AIRWORTHINESS DIRECTIVE GLIDERS:

GFA/AD/151

ROLLADEN SCHNEIDER 14

TYPES AFFECTED: L.S. GLIDERS - Versions LS 1-e, LS 1-ef, LS 1 f,
LS 2, LS 3. Technical Bulletin
No. 38/3013 refers

DRAWING N° 3R3-45
GFA AD151

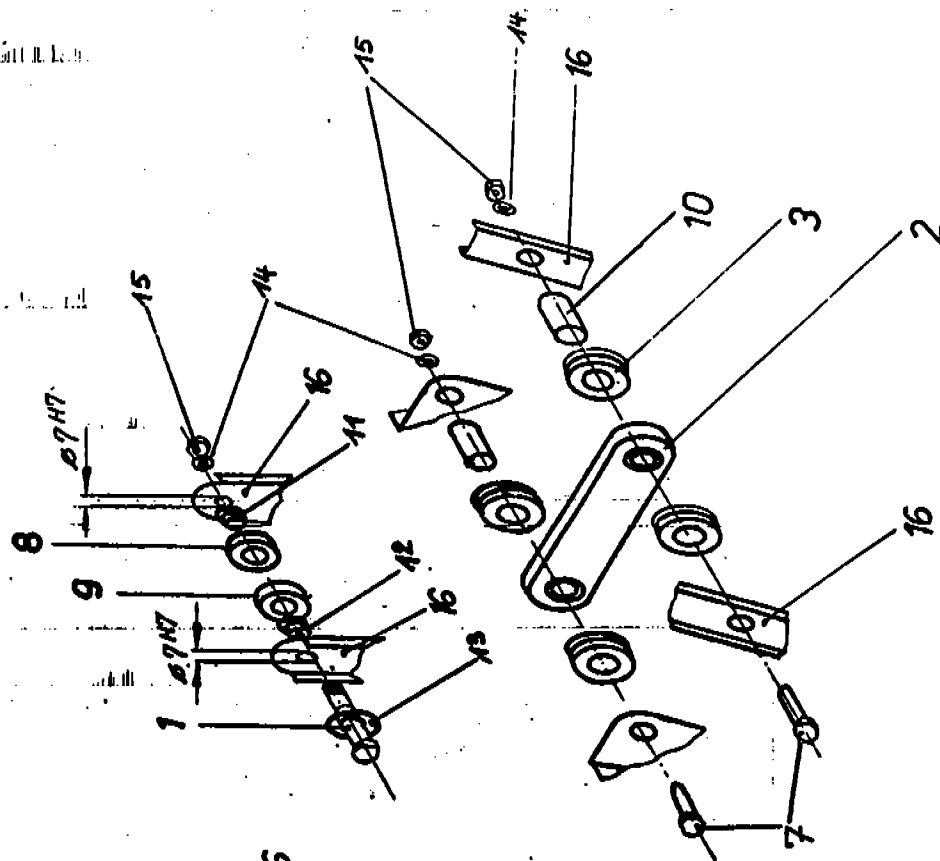
It has been found necessary to replace the spring member in the elevator actuator with a rigid member.

2. Modify elevator drive actuator according to the following instructions and drawing 3R3-45
 - (i) Remove the rudder taking careful note of the sequence of the washers at the lower bearing.

- (ii) Remove bolt (6) and open out 6 mm dia. holes in part (16) to 7 mm H7 tolerance.
 - (iii) Mark location of forward bolt (7) on the outside left hand side of the fin and drill a 12 mm ($\frac{1}{2}$ ") dia. hole.

- (iv) Remove forward bolt (7) through hole.
 - (v) Swing part (16) backwards until rear bolt (7) may be removed without damaging rear edge of fin.
 - (vi) Remove parts (4) and (5) and assemble part (2) according to drawing 3R3-45

- (vii) Assemble part (1) according to drawing but do not tighten nut completely.
 - (viii) Assemble horizontal tail unit and turn part (1) until elevator drive is free of backlash. Dot on hexagon head of part (1) marks maximum eccentricity. Elevator free play should be less than 2 mm at trailing edge when control column is fixed in neutral position of the elevator. After adjustment tighten nut on part (1) completely but do not overtighten.

- (ix) Check functioning of elevator and check range of travel and adjust push rods if necessary.
 - (x) Reassemble rudder ensuring that washers are replaced in the original order at the lower bearing.
